5					4					3					2					1																			
MODEL:					REV:					CHANGE LIST:															MODEL					ZU1									
ZU1 TOUCH PAD WITH FINGER PRINTER BOARD					1A					FIRST RELEASE															PAGE					FROM					TO				
					1B					PLEASE REFER TO ECN E200611-0701															1					1A					1B

PROJECT : ZU1
Quanta Computer Inc.

Size	Document Number	Rev
	TP/B WITH FP	2A
Date: Thursday, December 21, 2006		Sheet 1 of 1

TP/B

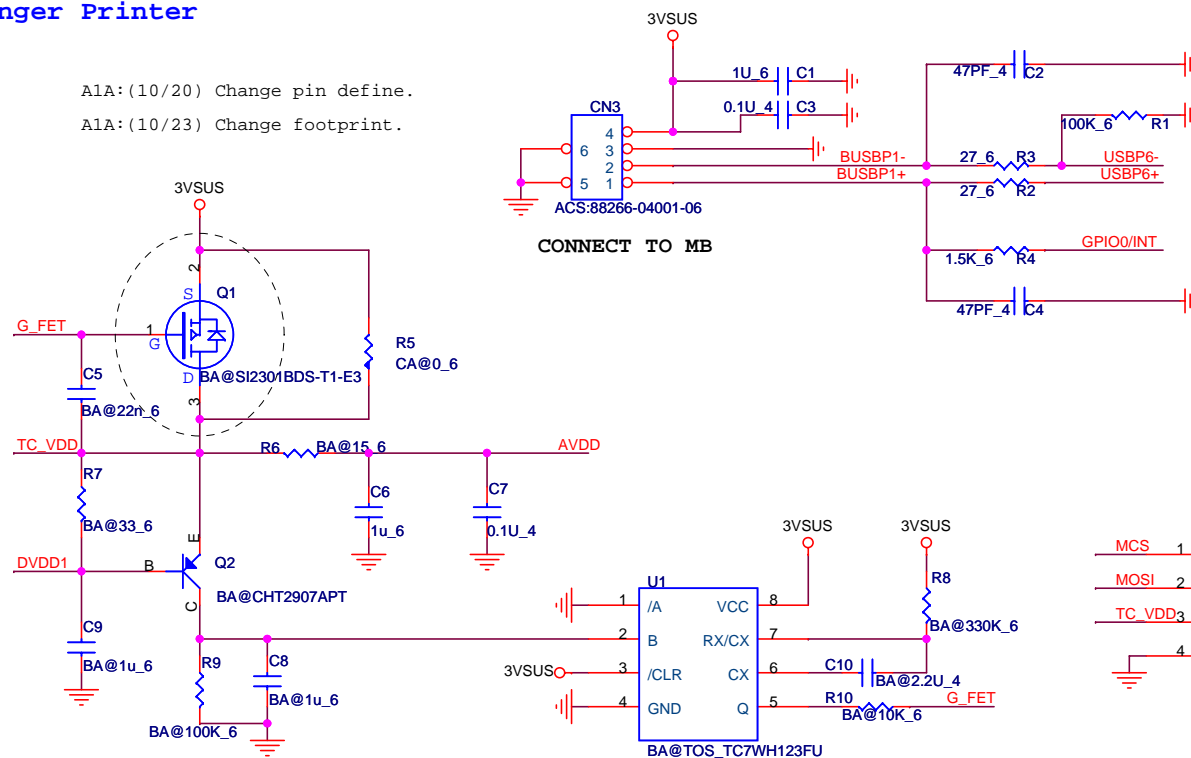
A1A:(10/25) Change SW1,SW2 from DHP00XB1G09 to DHP00BB1J03

A1A:(10/20) Change pin define.
A1A:(10/23) Change footprint.

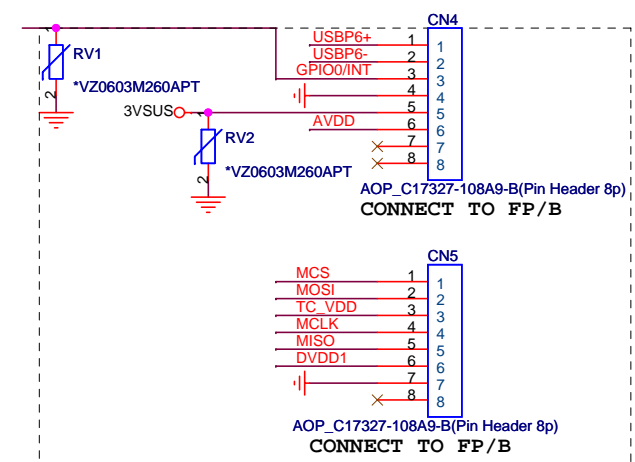
C2A:(12/21) Change CN4,CN5 from DFHD08MS002 to DFHD08MS004

A1A: (11/01) 1.Change Pin Hrader from 6pin to 8pin
2.Add RV1 & RV1 for ESD protection.
